STAFF REPORT

ITEM: Wyndham Village Preliminary Plat and Zoning Map Amendment

Re: Wyndham Village Preliminary Plan Review

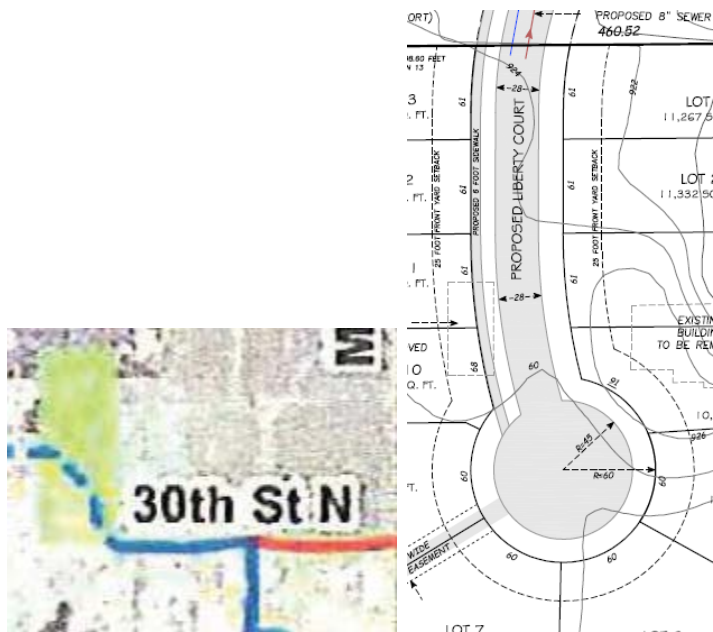
Usable Backyard Issue. The developer has revised the proposed sketch plan that was previously submitted to the city. The initial sketch plan did not provide backyards that the City had felt were usable, as a 66 foot wide Northern Natural Gas Easement ran along the majority of the backyards of the lots to the west of Liberty Court North. The proposed preliminary plat reduces the number of proposed lots from 13 to 10, as approved by Council, reducing the proposed density from 2.17 units per acre to 1.67 units per acre. Additionally, the developer had provided an exhibit which shows proposed building pad locations that show a 20 foot rear yard principal building setback from the Northern Natural Gas Easement. This exhibit shows that a pool and play set could reasonably fit within these backyards. The standard rear yard setback for properties located within the Village Low Density Residential Zoning District is 20 feet, and so Staff believes that so long as the lots in which the Northern Natural Gas Easement is located maintain a 20 foot principal building rear yard setback from the easement that these proposed lots will provide a sufficient rear yard. This has been added as a recommended condition of approval.

Density. The total site acreage is 5.97 acres, and the proposed number of homes is 10. Because none of the area within the proposed preliminary plat can be netted out (i.e. none of it is arterial right-of-way or parkland), the proposed density is 1.67 units per acre. This is within the required density of the Village Urban Low Density (1.5-2.49 units per acre).

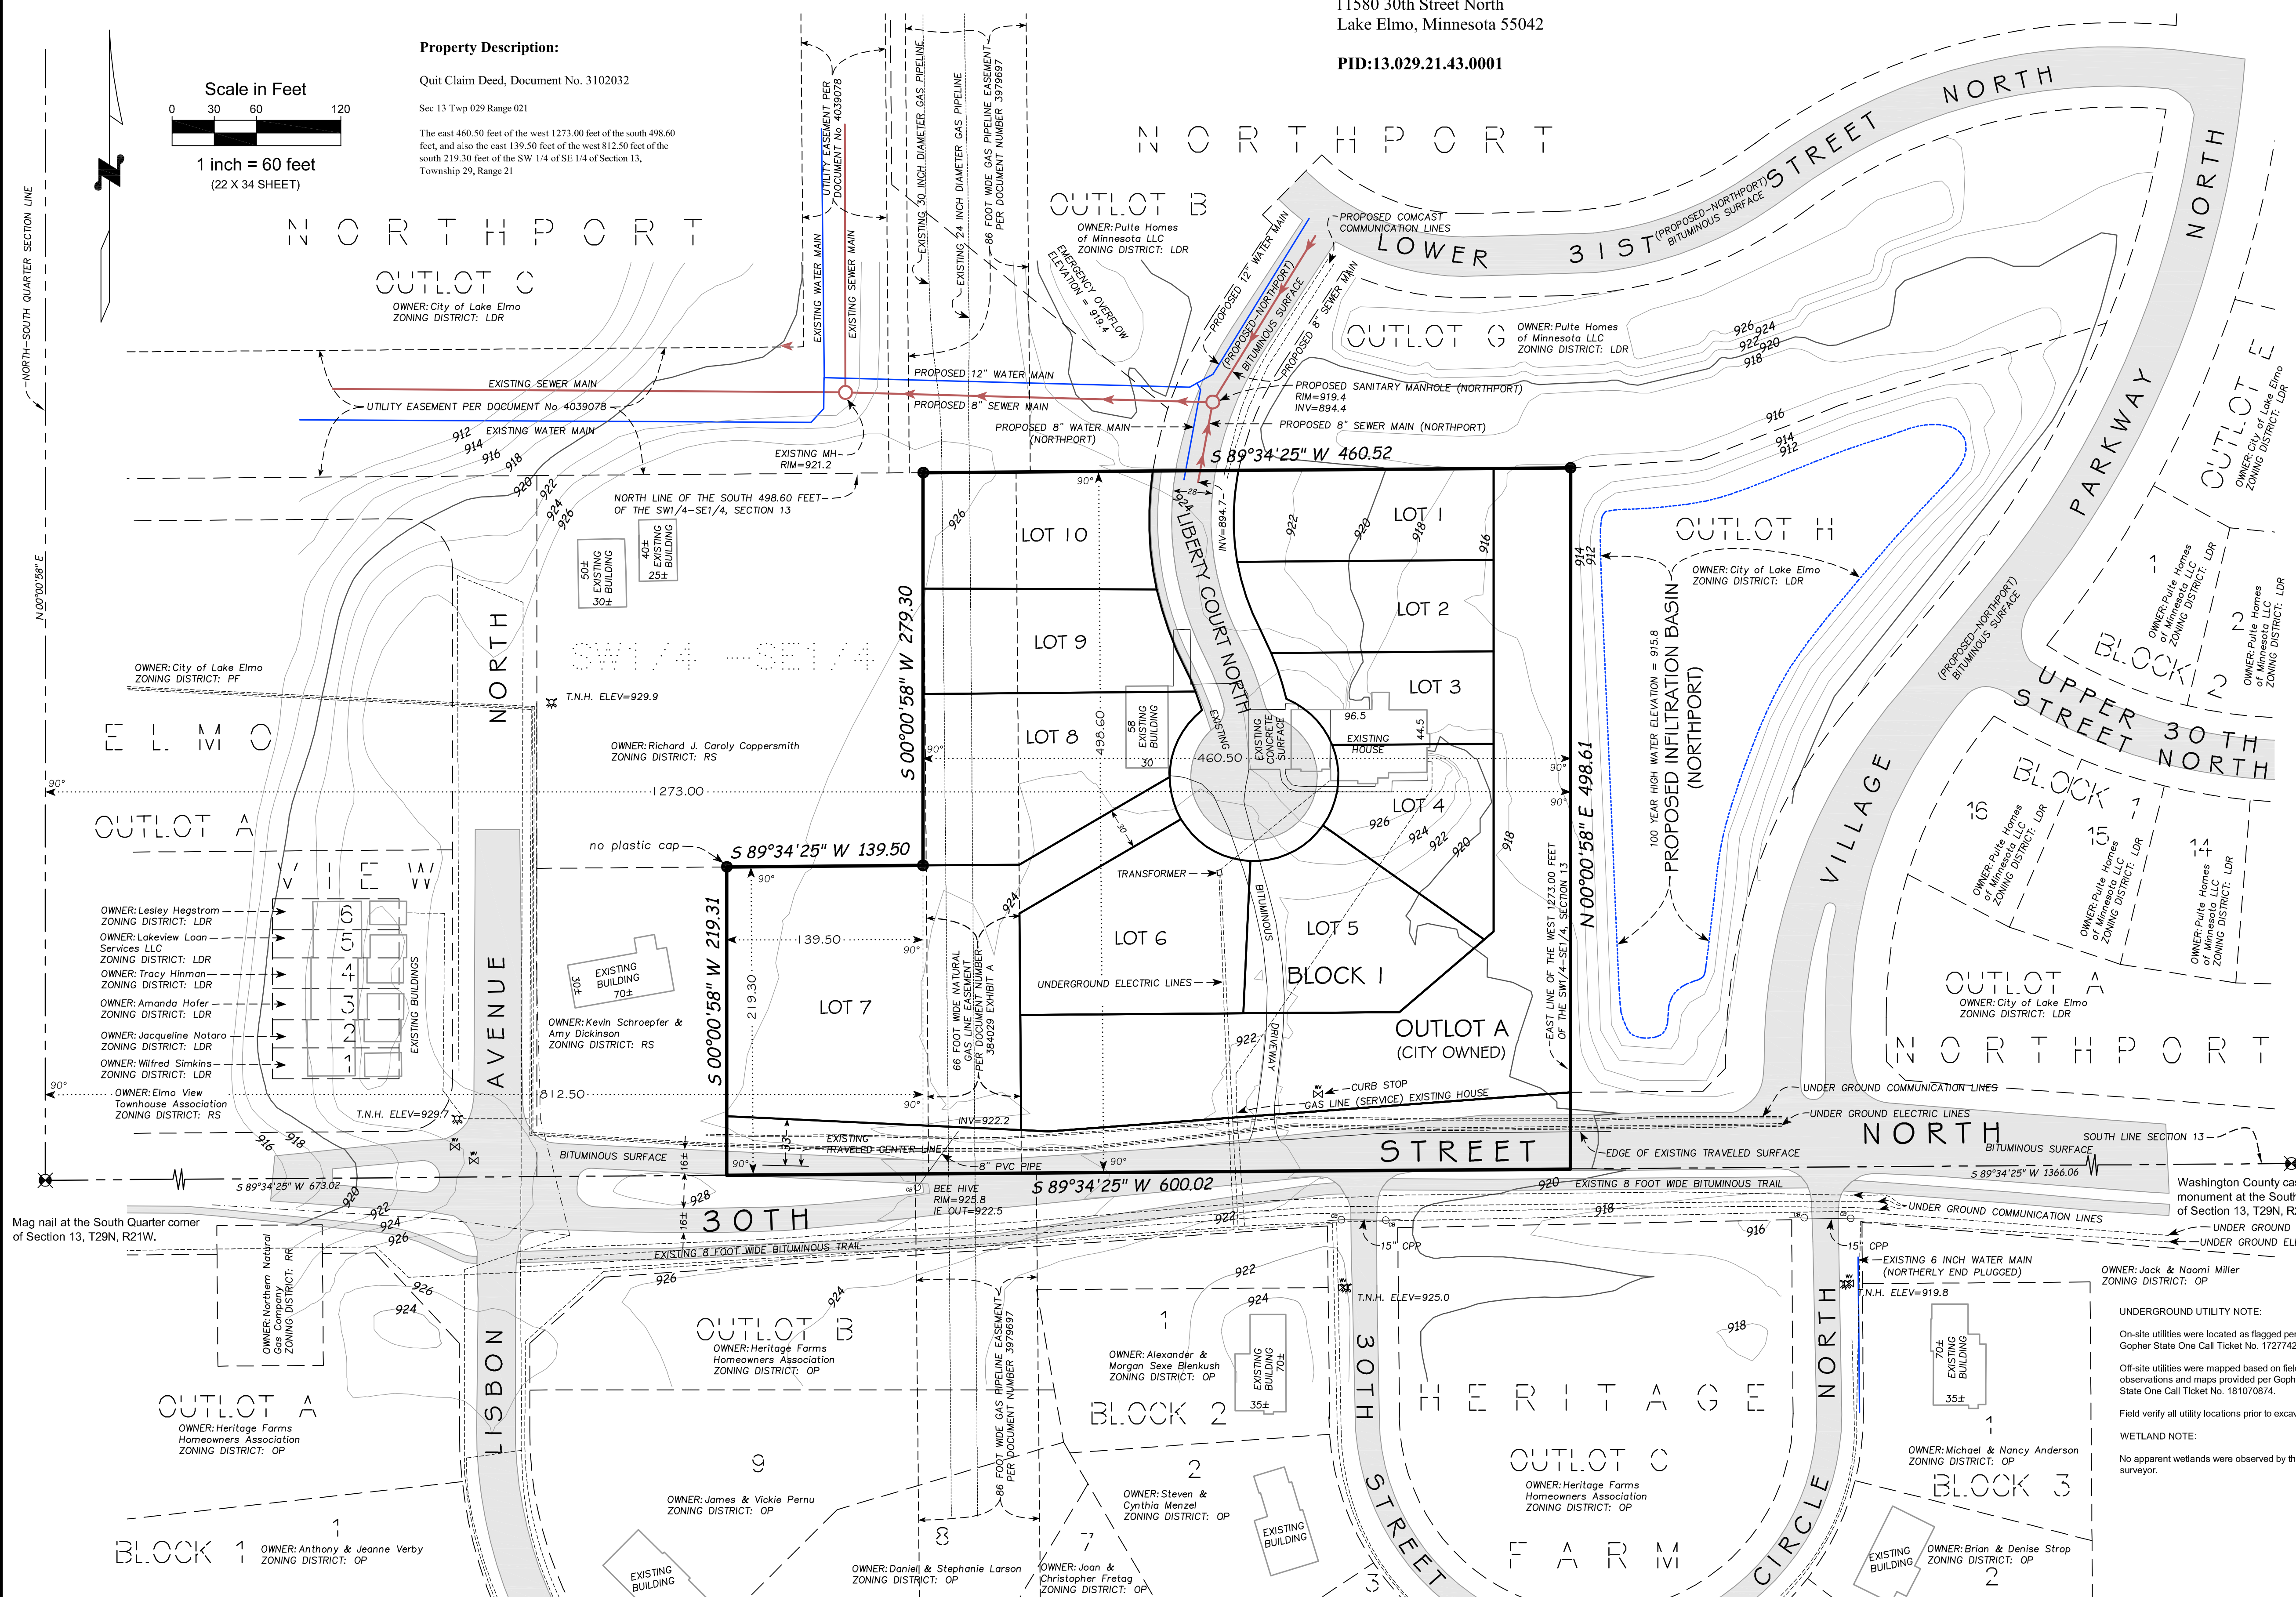
Lot Dimensions and Bulk Requirements. The proposed sketch plan appears to meet the lot dimensions and bulk requirements for the Village Urban Low Density Residential zoning district, except for Lot 1. This is the only lot that does not meet the required lot width at the setback line. It is a recommended condition of approval that this lot width be increased to 70 feet.

- Right-of-way/Easement Dedication. The Preliminary Plat and all preliminary plan sheets must be revised to dedicate additional right-of-way along 30th Street North to ensure a minimum 30th Street boulevard of 16 ft. along the entire length of the plat. The current plans show a varied boulevard width from 11-25 feet. In addition, a 10 ft. utility corridor must be reserved (at boulevard grades) for small utilities. The proposed storm water facilities (including the 100-year HWL) must be revised further north to prevent encroachment onto the 10 ft. utility corridor.

- Outlot A must be dedicated to the City for storm water maintenance. Outlot A has been shown as City-owned on the preliminary plat and plans as required. Outlot A may need to be revised to accommodate additional right-of-way along 30th Street and/or to expand the storm water 100-year HWL flood area.

- Drainage and utility easements are required over all storm sewer, sanitary sewer and watermain not located on City Outlots and right-of-way, minimum 30-feet in width centered on the pipe/structure. Easements must be shown on the Preliminary Plat, Utility Plans and Grading Plans.

9. The preliminary landscape plan shall be approved by the City prior to recording of the final plat.
10. The lot width of Lot 1 shall be increased to 70 feet, and all other lot dimension and bulk requirements of the Village Urban Low Density zoning district must be met.

WYNDHAM VILLAGE
LAKE ELMO, MN
PRELIMINARY LANDSCAPE PLAN

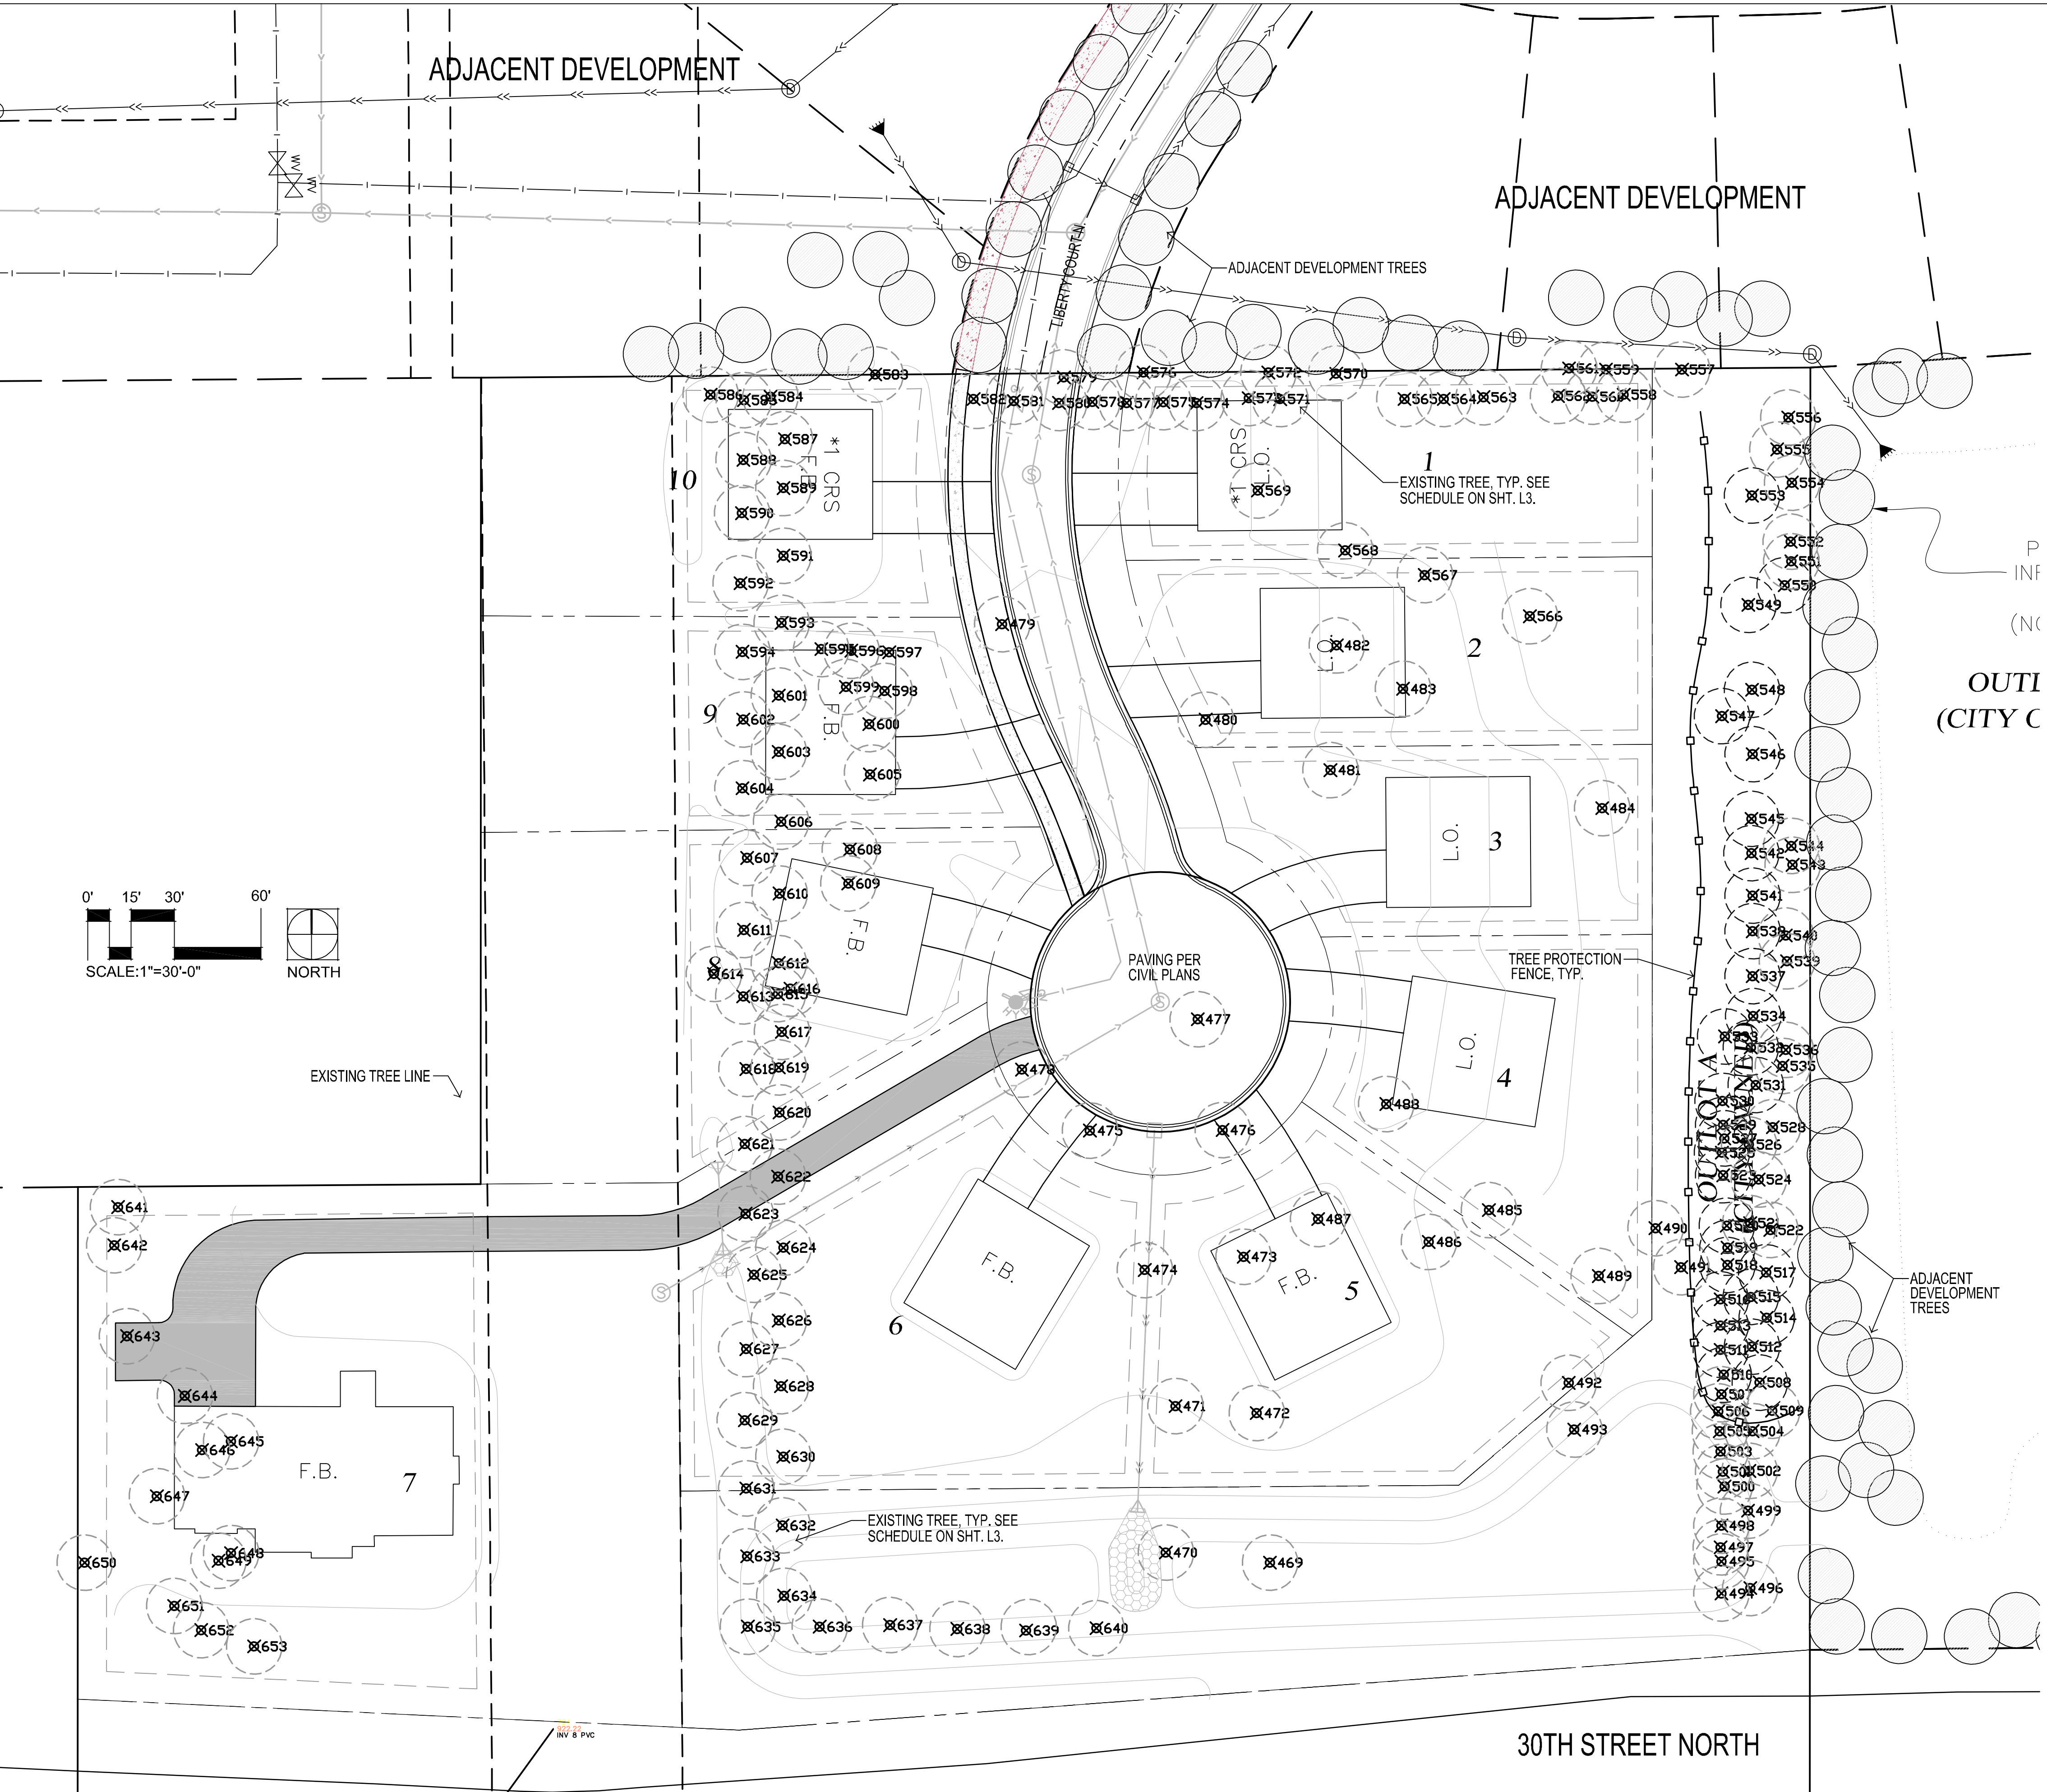
- This review does not cover the Landscape Plan or Irrigation Plan. Plan review to be completed by other City representatives.
- The Landscape Plans must be revised to accommodate maintenance access to all storm water BMPs. Grades along pond access cannot exceeded 10% and must be a minimum of 20 feet in width. Maintenance access from public right-of-ways must be shown on the Landscape Plans.

The Preliminary Landscape Plan appears to indicate that many existing trees will be relocated to a new location on the site. MAC requests that, if feasible, any new trees introduced to the site be of a non-fruit bearing species to minimize wildlife attractiveness. The City must also be aware that any trees planted in the vicinity of an approach to a runway may require removal or trimming (at the Owner's expense) at some future date if they grow to become an obstruction to the airspace of the Airport or compromise flight procedures.
